HERITAGE EAST SUBDIVISION

Attn: Tyson Stoddard, Planner
Proj: Heritage East Subdivision
Subj: Plan review #2 – Resubmittal

I have reviewed the submitted plans shared on Bluebeam for Heritage East Subdivision. The plans have some comments that will need to be addressed prior to our recommendation of approval.

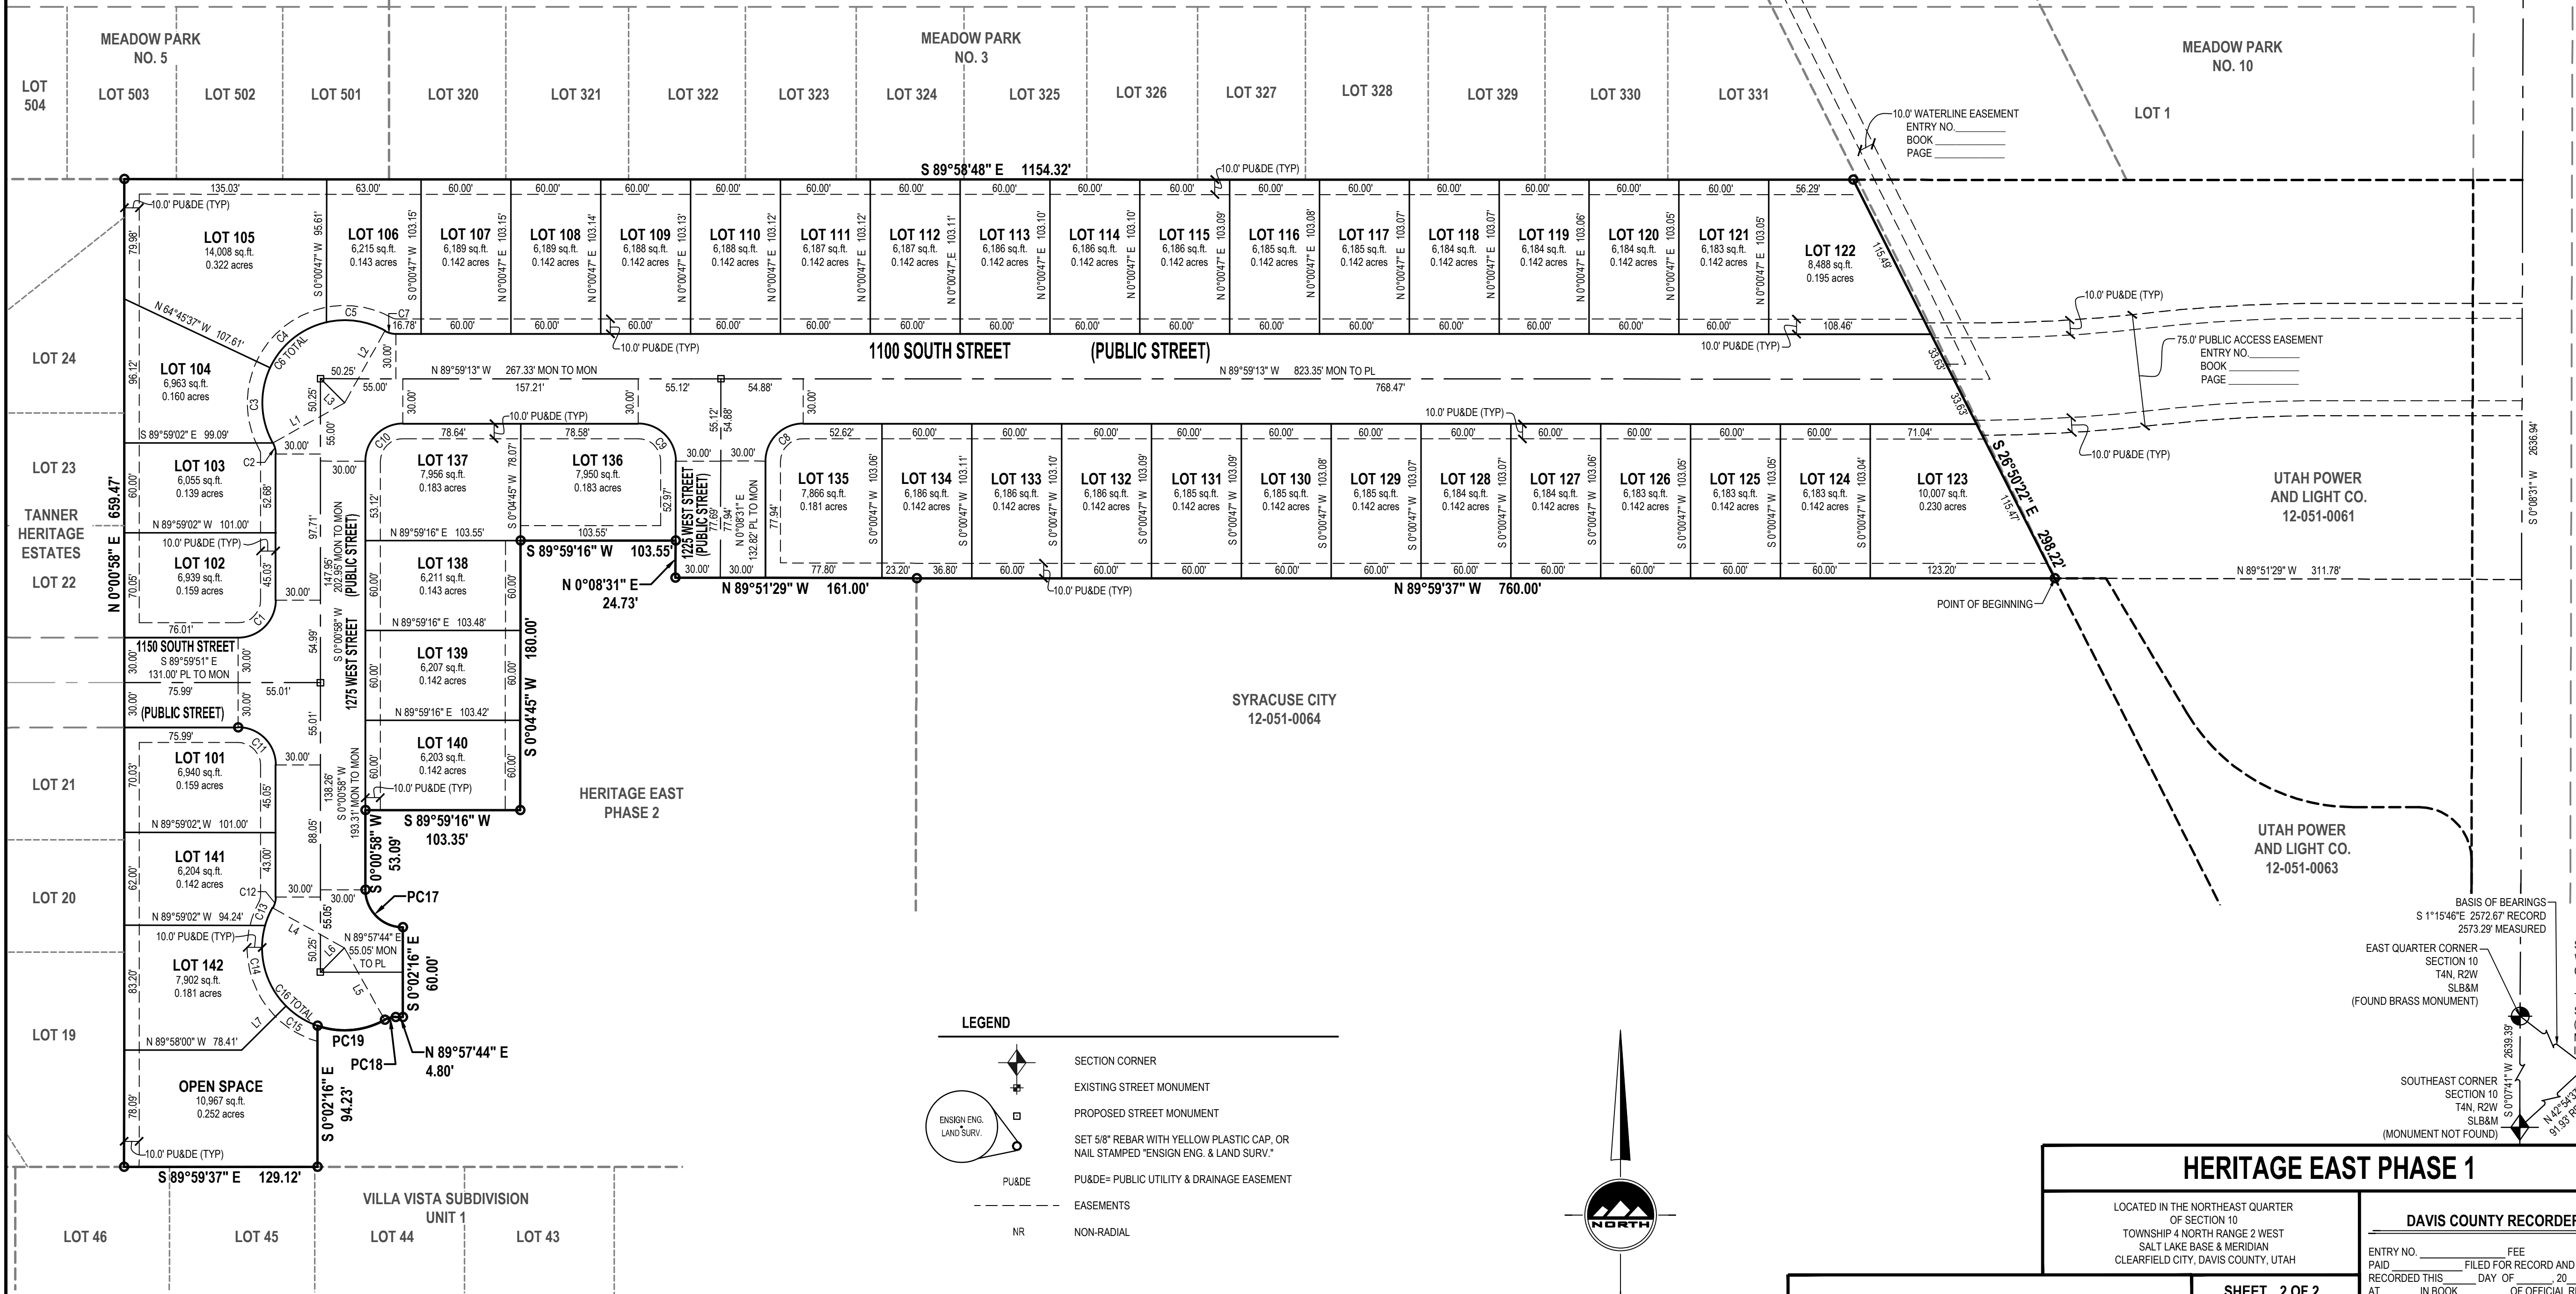
1. The boundary description is lacking on the Plat
2. A 10' PU + DE needs to be shown on the front and rear of all the lots
3. An easement for 1100 S. going underneath Rocky Mountain Power utility lines needs to be shown.
4. Lot 203 on the Phase 2 Plat should be dedicated as open space, including a note for who will be responsible for maintaining the property (combine with neighboring lot, HOA responsibility, etc.)
 - a. As a result of Lot 203 being dedicated as open space, lot #'s do not match starting on sheet C-100.

OVERALL GRADING/
DRAINAGE PLAN

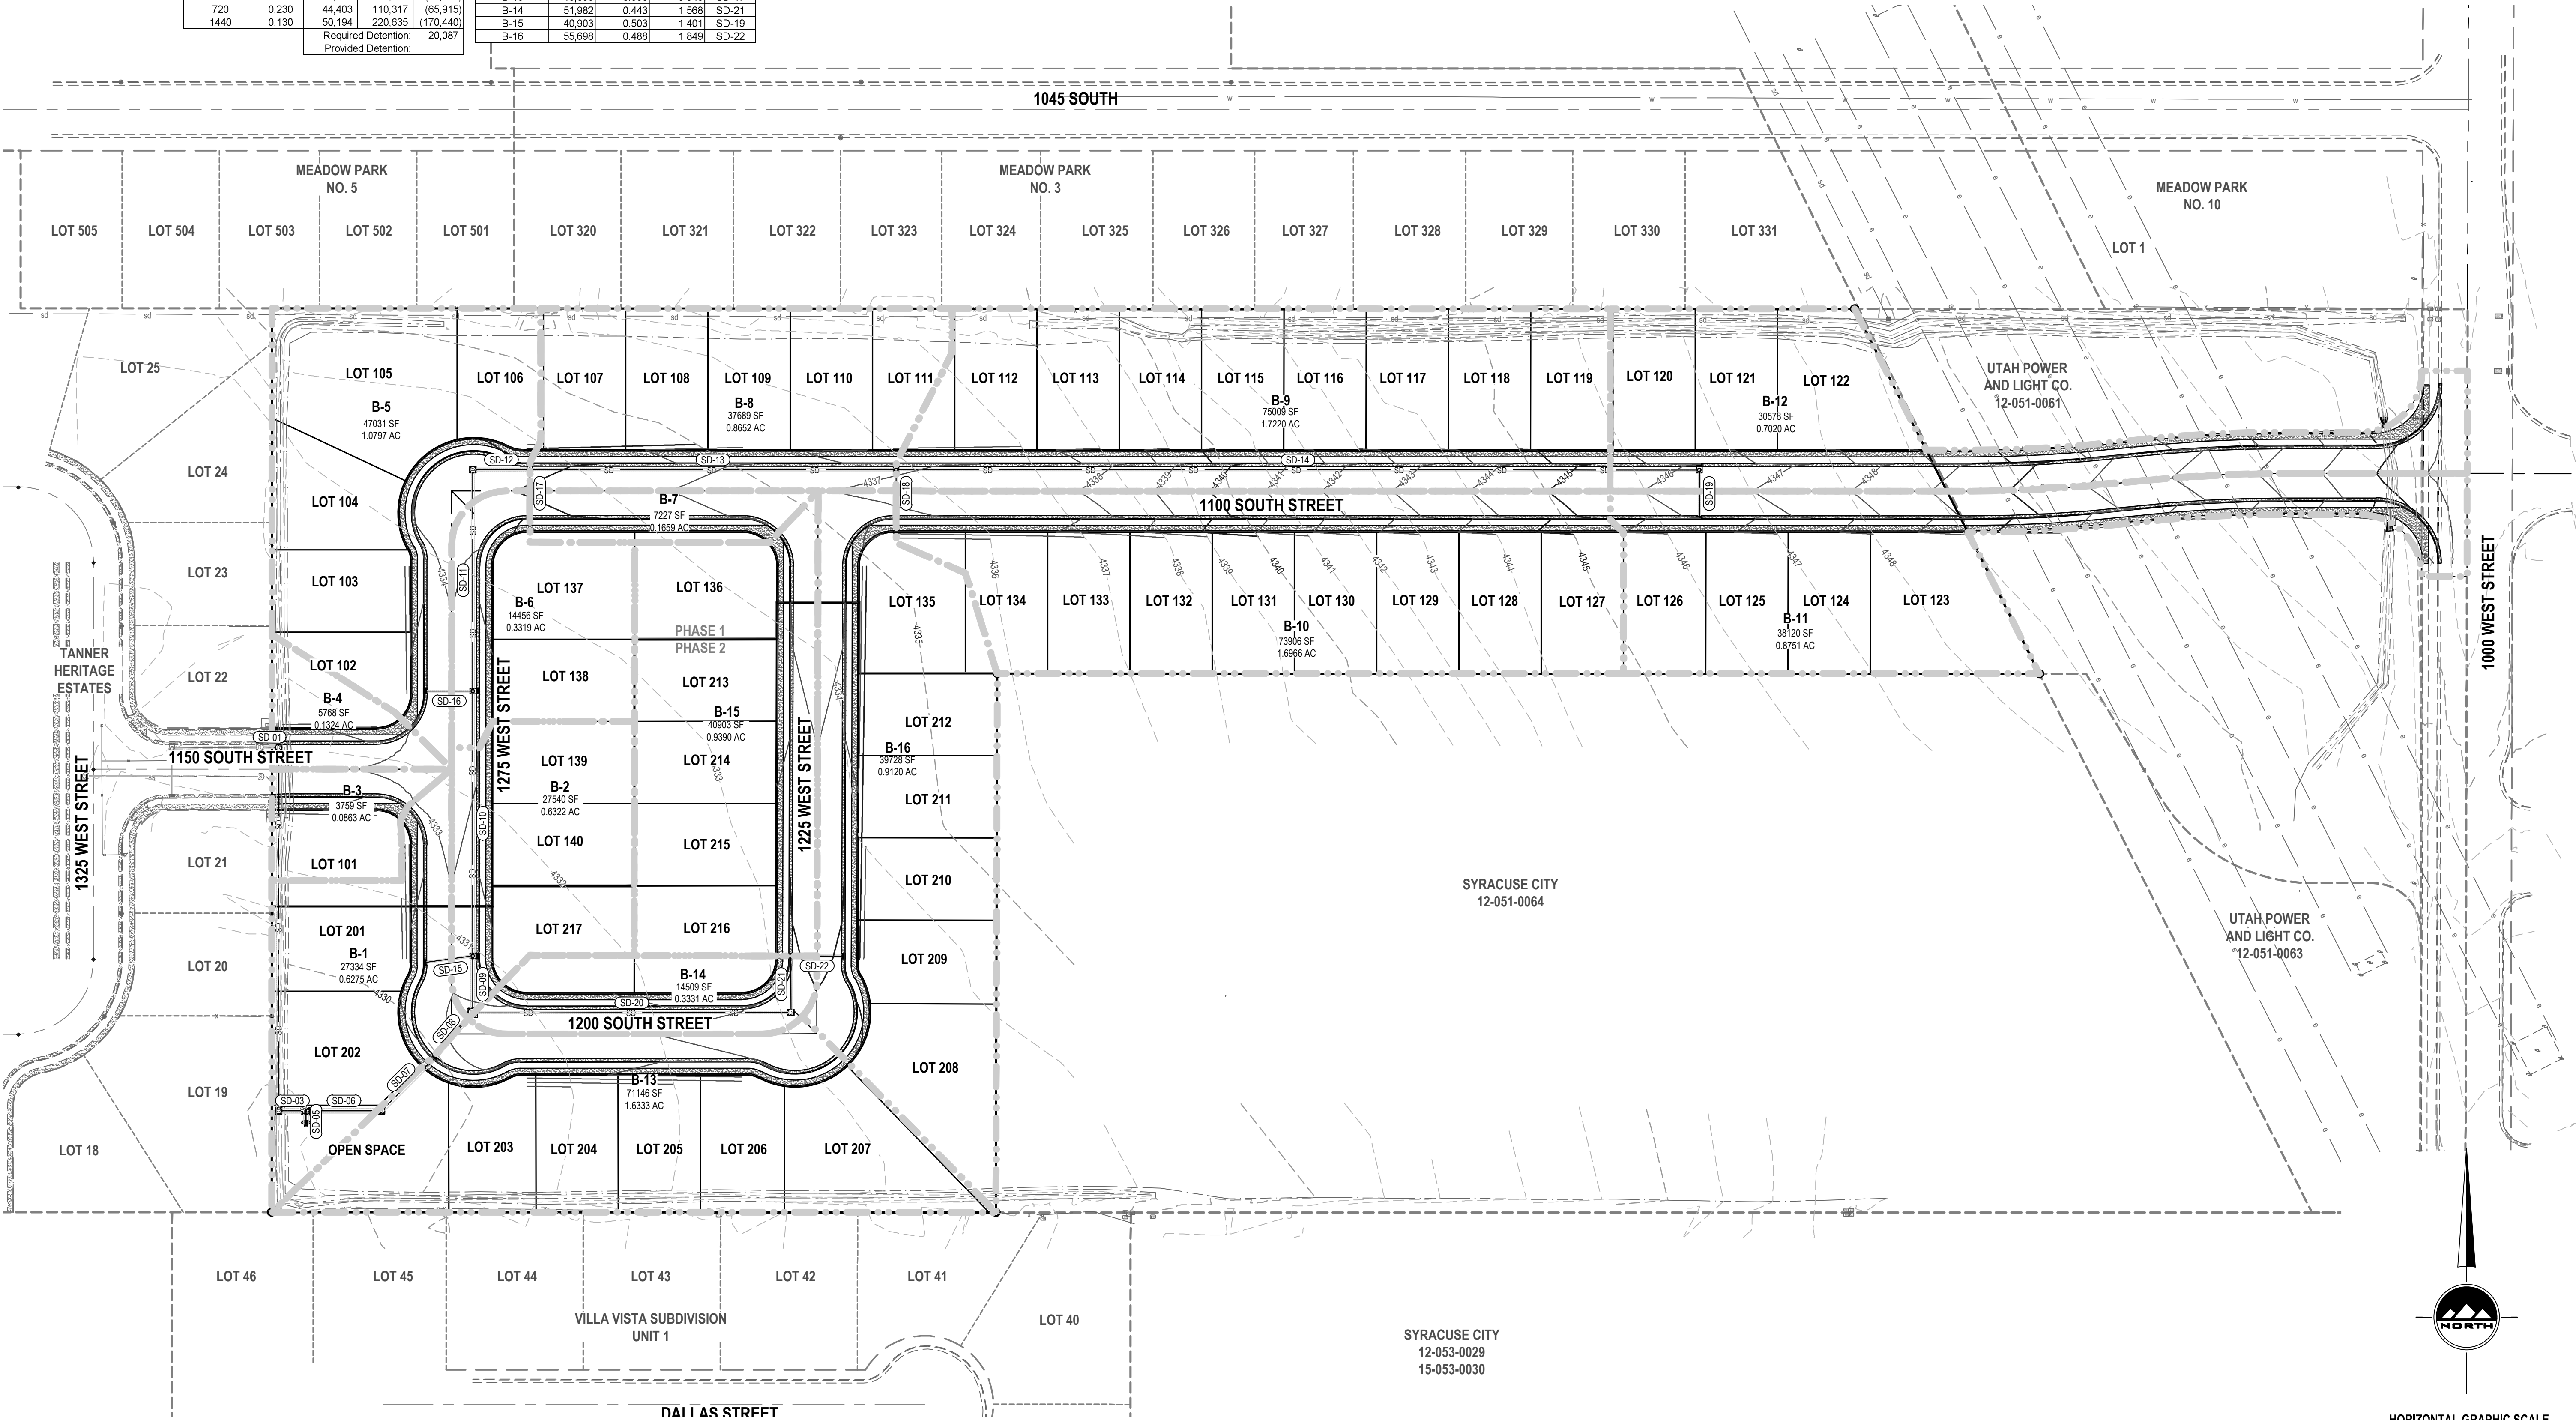
1. The finish grade question mark boxes need to be filled with appropriate information.
2. The South, West, and East sides of the open space pond should be built up as to have a higher elevation than the Northeast end for any overflow from a storm event to spill into the street rather than the bordering residential lots.
3. We suggest 3 water valves be placed on the intersection of 1225 W and 1100 S for maintenance and control of the publicly owned water line.
4. Sheet PP-3 "TBC Data" needs to be completed with appropriate information.
5. The open space pond inlet details and specs need to be shown.
6. Clarification is needed for the proposed irrigation line on the North property line running East to West.
